# **Request for Additional Information for General Electric – Morris Operation License Renewal Application**

**General Electric Corporation  
Morris Operation  
Docket No. 72-1  
SNM-2500**

**Basis for evaluating Structures, Systems and Components within the scope for license renewal. (Figure 3.0-1)**

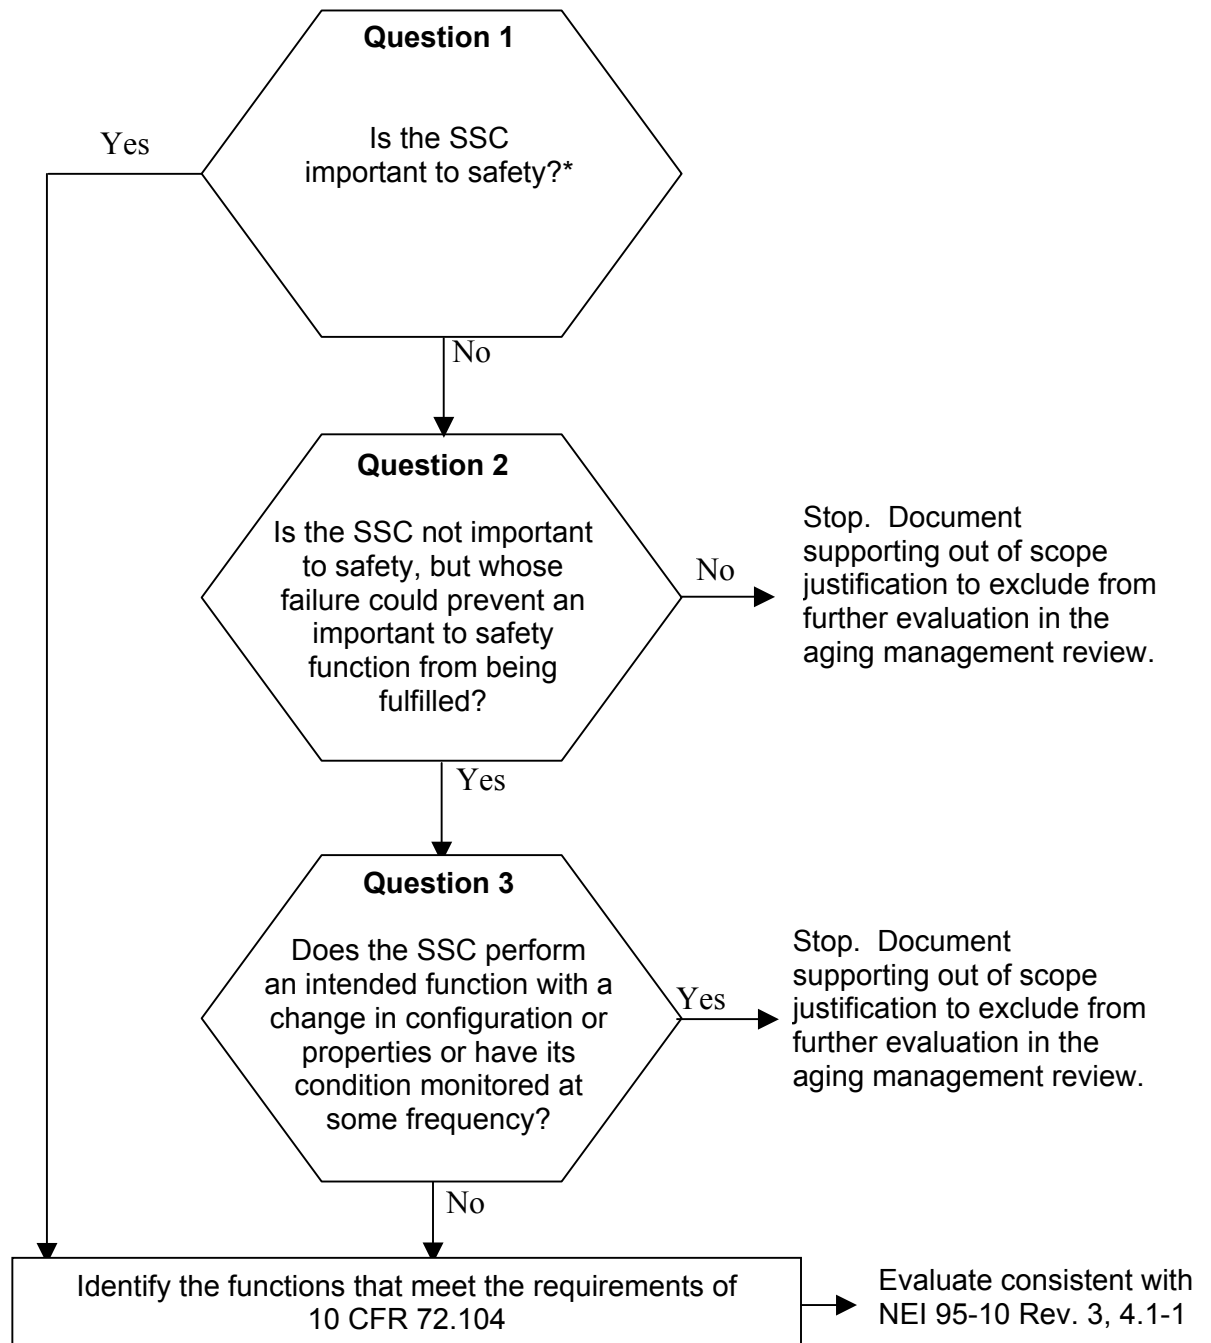
1-1 Provide a list of SSCs that are subject to an AMR and a list of SSCs that are not subject to an AMR. Describe the process used to determine the SSCs that are subject to an AMR.

For each Structure, System and Component in the Plant  
Process the SSC through the following flow path using applicable information sources  
consistent with NEI 95-10 Rev 3, Table 3.1-1

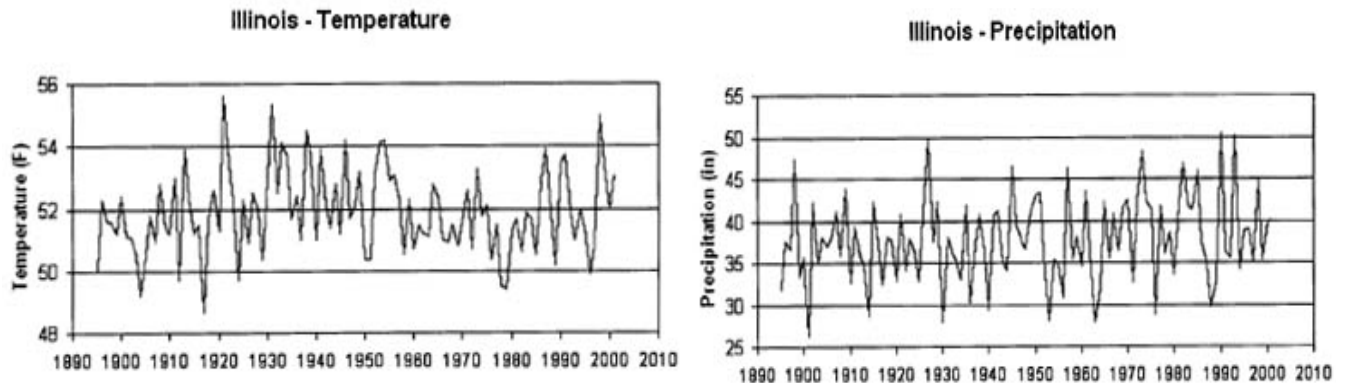
- a. Table 3-4 Aircraft flight information is from 1979;
- b. Table 3-6 Precipitation information is from 1964;
- c. Figure 3-8 Wind rose data is from 1971;
- d. Figures 3-3, 3-4, 3-5, and 3-6 Population Data is from 1990;
- e. Table 3-7 Thunderstorm activity information is from 1976;
- f. Table 3-8 Stability class and wind direction information is from 1974;
- g. Table 3-12 Water analysis information is from 1977; and
- h. Figure 7-1 History of Basin Water Activity ends in 1994.

**Response – a. The aircraft flight data in Table 3-4 is referenced to VOR flight tracking. As per FAA regional office, since flights use GPS now, this system is no longer used and an update of the info is not possible. The information was retained in the CSAR to depict there are no scheduled flight lanes over GE-MO.**

**b. Table 3-6 has been updated to include information from 1948 through 2001.**

**d. Figures 3-3, 3-4, 3-5 and 3-6 are used to demonstrate anticipated population growth for the period 1990 to 2015. Table 3-1 has been revised to the 2000 US Census results.**
